PREVOST

Warranty Bulletin

95-32A

Date: **October 1995**
 Section: **22**
 Subject: **HOT WATER VALVE CONTROL - PREHEATING SYSTEM**
 Revision A:

FIGURE 1: FRONT ELECTRICAL COMPARTMENT - DDEC II

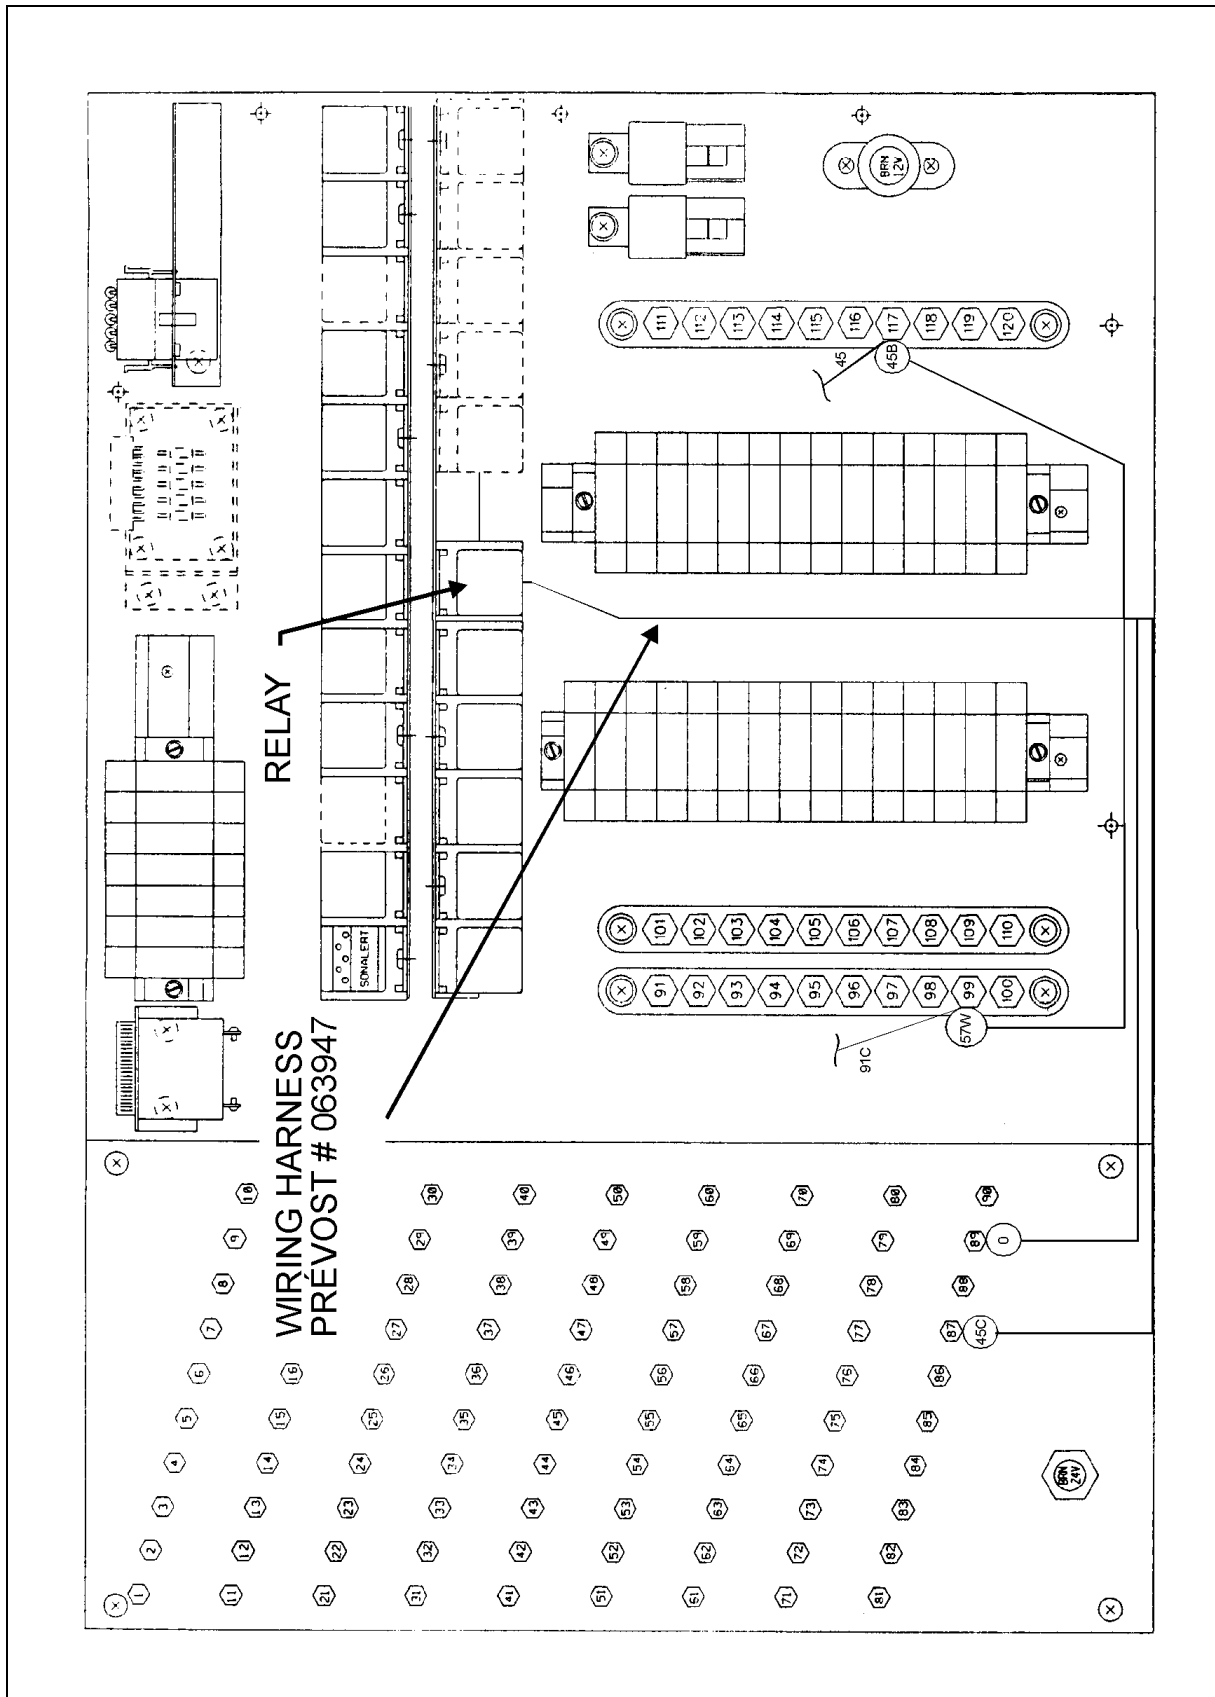
WITH SERIES 60 ENGINE, DDEC II (Figure 1)

- Connect wire #91C to post #99. On certain vehicles wire #91C is connected to post #77. If this is the case, disconnect wire #91C from post #77. Connect wire #91C to post #99.
- Connect extremity #57W of the wiring connection (Prévost #063947) to post #99.
- Disconnect wire #45 from post #87. Connect wire #45 to post #117.
- Connect extremity #45B of the wiring connection (Prévost #063947) to post #117.

FIGURE 2: FRONT ELECTRICAL COMPARTMENT - DDEC III

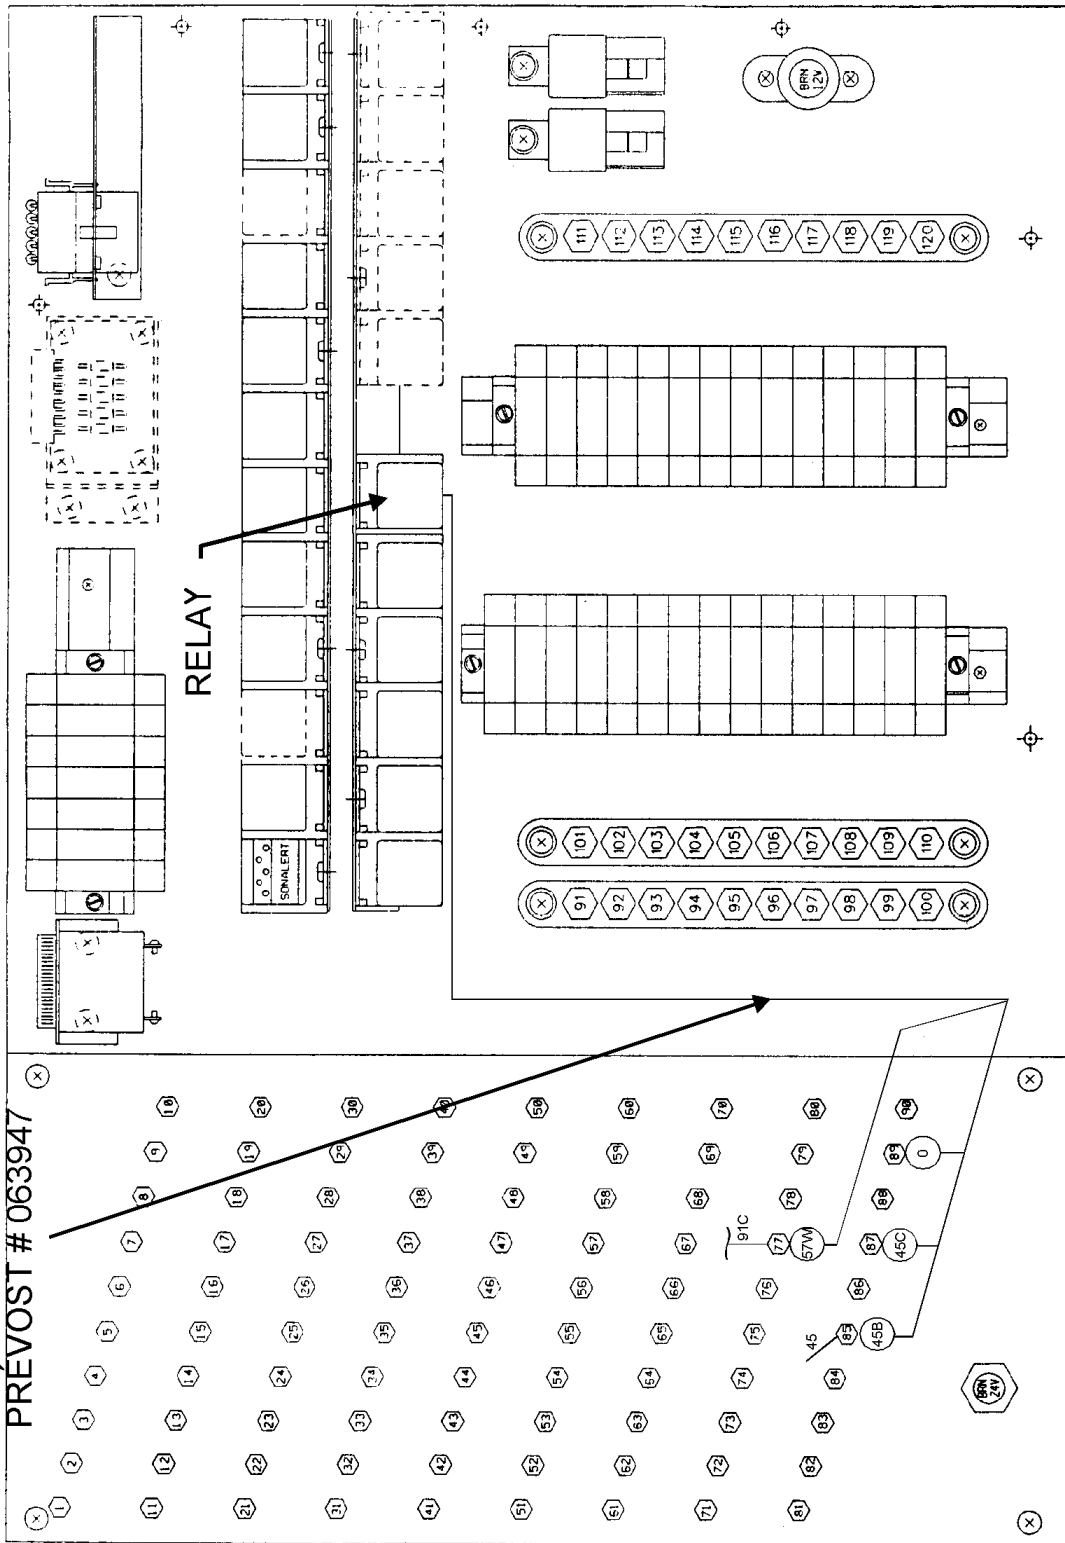
WITH SERIES 60 ENGINE, DDEC III (Figure 2)

- Connect wire #91C to post #77. On certain vehicles this connection has already been connected in factory. If this is the case, leave wire #91C connected to post #77.
- Connect extremity #57W of the wiring connection (Prévost #063947) to post #77.
- Disconnect wire #45 from post #87. Connect wire #45 to post #85.
- Connect extremity #45B of the wiring connection (Prévost #063947) to post #85.

B) COACH WITH SERIES 60 ENGINE, DDEC III (FIGURE 2)

- All coaches have wire #91C as spare. Connect wire #91C to post #77.
 - Connect extremity #57W of the wiring connection (Prévost #063947) to post #77.
 - Disconnect wire #45 from post #87. Connect wire #45 to post #85.
 - Connect extremity #45B of the wiring connection (Prévost #063947) to post #85.
6. Install the relay base. Drill a hole to receive the screw (Prévost #500557) that will secure the relay base.
 7. Connect relay to it's base.
 8. Connect extremity #0 of the wiring connection (Prévost #063947) to post #89.
 9. Connect extremity #45C of the wiring connection (Prévost #063947) to post #87.
 10. Secure wiring harness using cable ties (Prévost #504012).
 11. Close the front electrical door.
